# Access Compliance Report

## Public Rights-of-Way

| Intersection ID: 10156                  | Main Street: BEATTIES_FORD_RD | Cross Street: MILL_RD                   | Location: SW           |
| ADA ID: 3577BAC8CDEE                    | Ramp Type: PerpDiag           | Initial Pass/Fail: Fail                 | Overall Compliance: No |

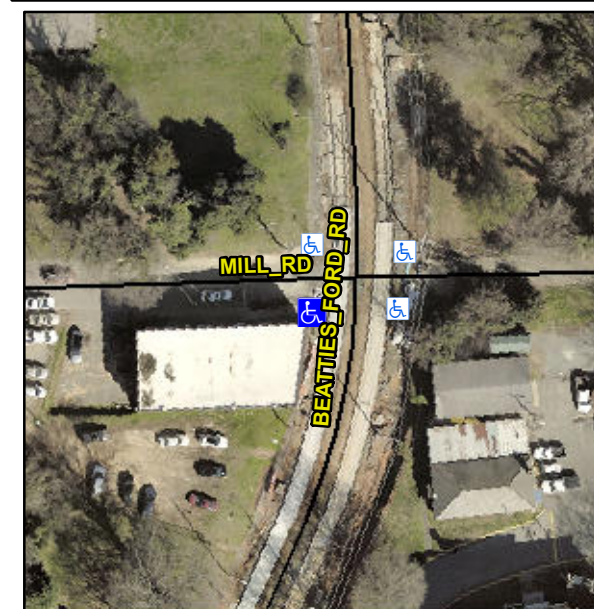
**Not Found, R304.2.2**

| Compliance | Description           | Data | Compliance | Description                 | Data |
|------------|-----------------------|------|------------|-----------------------------|------|
| N/A        | Ramp Length (in)      | 49.0 | No         | Ramp Slope (%)              | 14.1 |

**Remove & Replace Curb Ramp With Two New Directional Ramps or Equivalent.**
